Mandatory Service Bulletin

ENGINE COMPONENTS, INC.

M.S.B. No.: 05-8

Title: REPLACEMENT OF CLASSIC CAST CYLINDERS IN COMPLIANCE WITH AIRWORTHINESS DIRECTIVE 2006-12-07

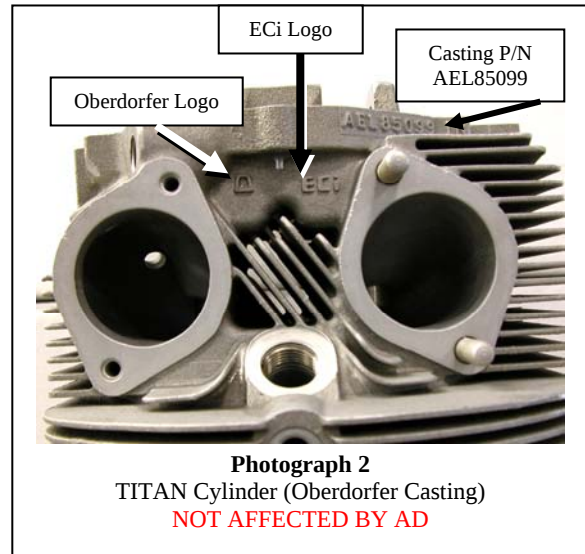
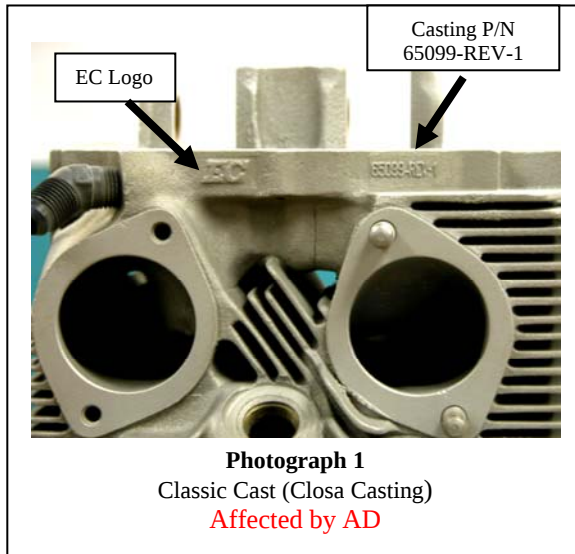
- 5.0 CYLINDER IDENTIFICATION:** The ECi Classic Cast cylinders that are affected by this AD are identified through several unique features. The primary identification feature is the casting part number, 65099-REV-1, which is cast into the cylinder rocker flange above the exhaust port as shown in Photograph 1 (next page.) Classic Cast replacement cylinders for Lycoming parallel valve engines have this unique number while the TITAN® brand cylinders, which are **NOT** the subject of this Mandatory Service Bulletin, have casting number AEL85099 (See photograph 2 next page.)

The “EC” logo on the Classic Cast heads is also on the rocker flange toward the intake port side of the cylinder head (Photograph 1), whereas the TITAN cylinder has the Oberdorfer logo as well as the ECi logo, instead of just “ECi” (Photograph 2.)

The cylinder serial number is marked on the side of the cylinder below the rocker cover flange on the intake side. Cylinders with part number 65099-REV-1 as described in Photograph 1 (above) **AND** with serial numbers that are between 110 and 9879 (and may have prefix “L” if cylinder spark plug boss is long reach) are affected by this service bulletin and AD 2006-12-07. Photograph 3 (below) describes the location of the serial number which must be 9879 or lower. **Cylinders with serial numbers 9880 or higher are not affected.**
